**Rules and
Regulations for
the Classification
of Naval Ships,
January 2008**

Notice No. 2

Issue date: September 2008

This Notice contains amendments within the following Sections of the *Rules and Regulations for the Classification of Naval Ships, January 2008*. The amendments are effective on the dates shown:

Fig. 2.2.2 Sea areas

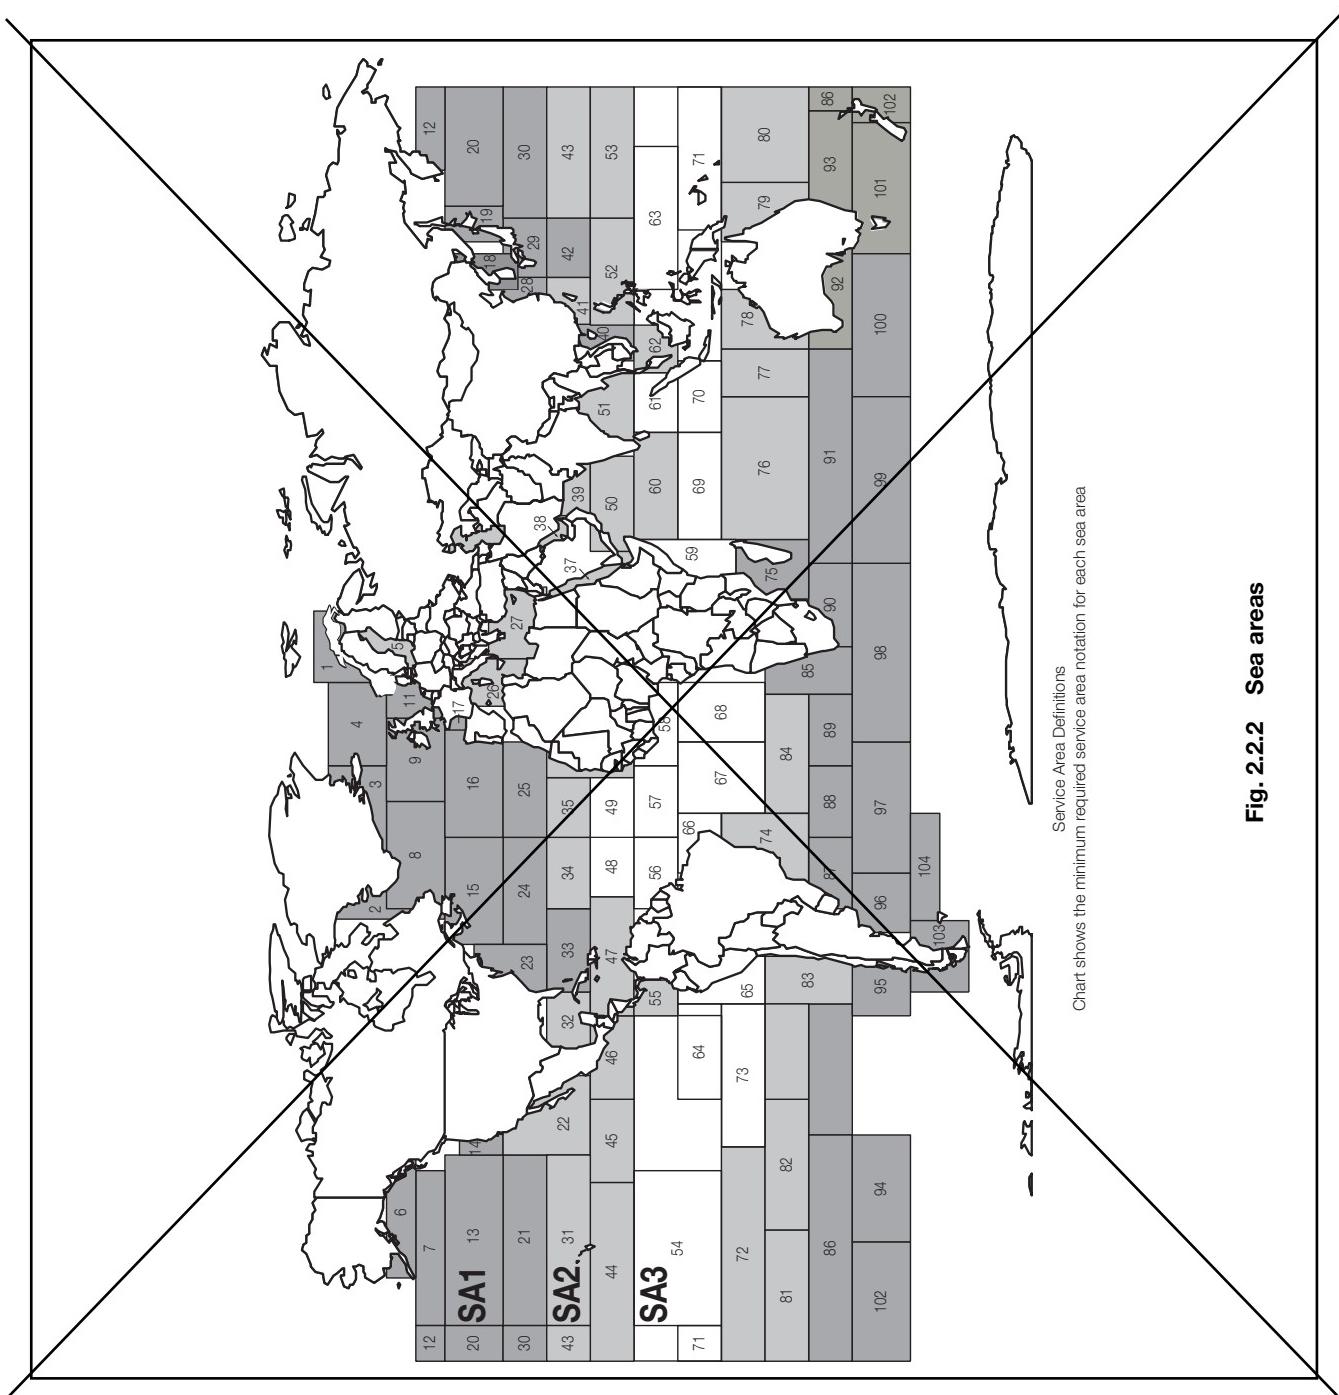
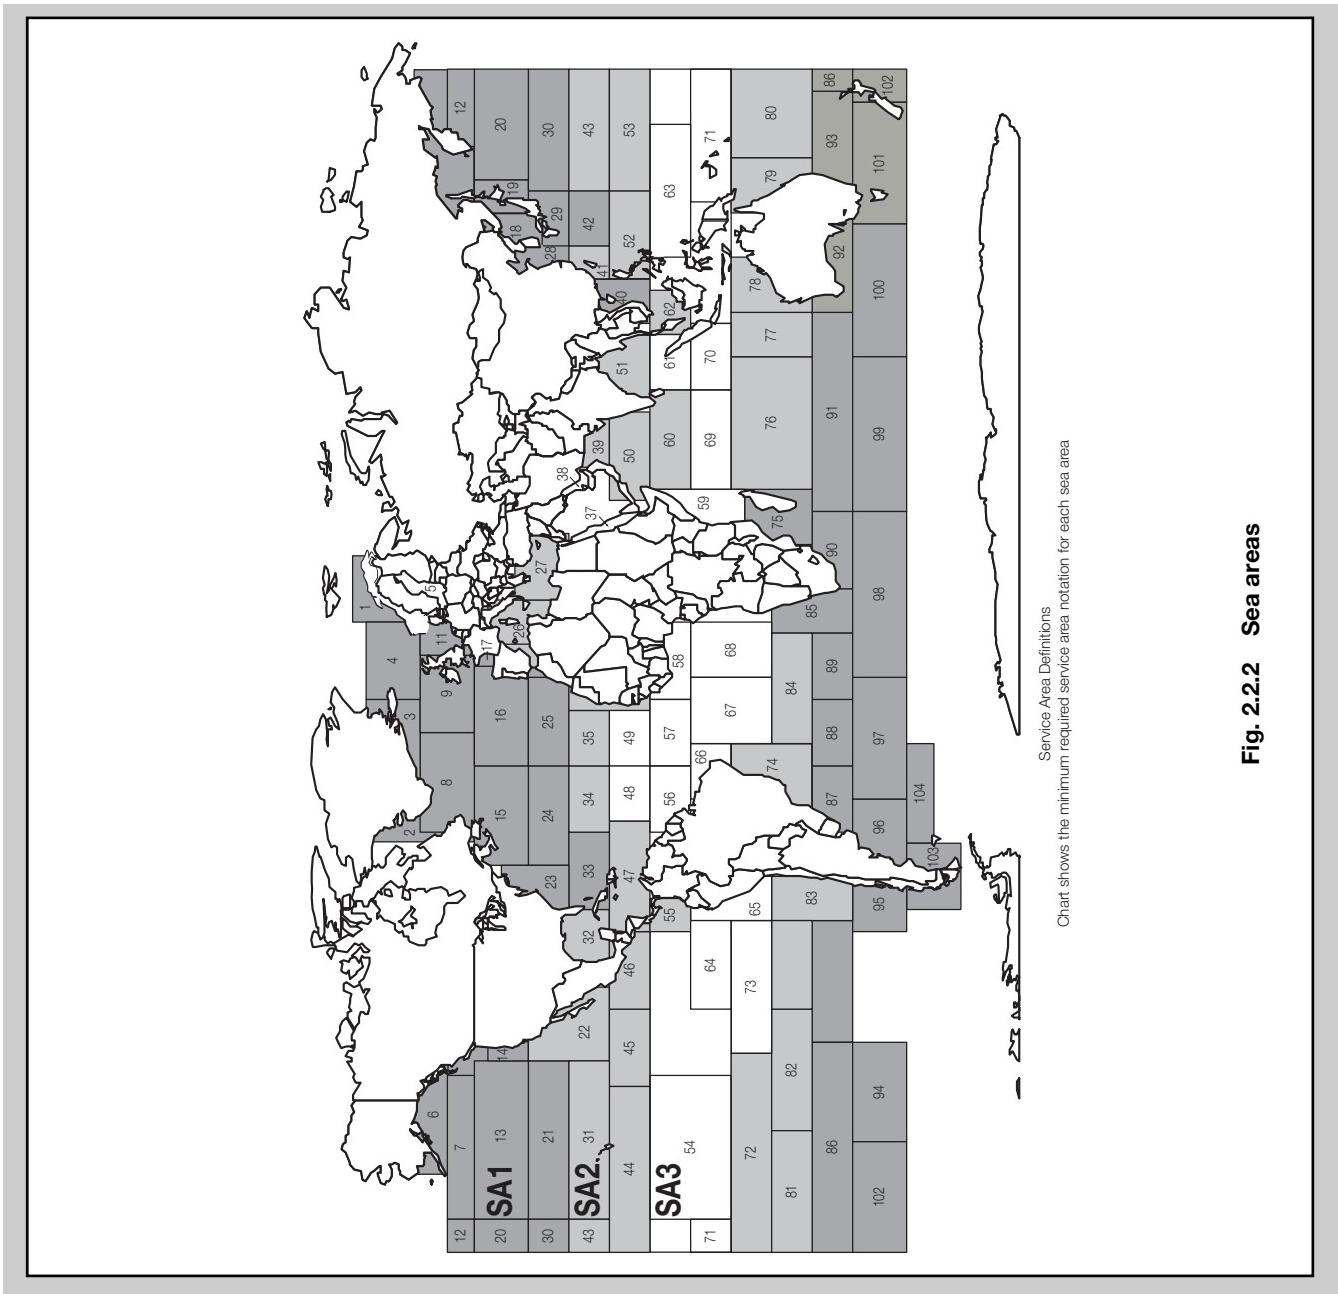
CORRIGENDA

2.3 Wave environment
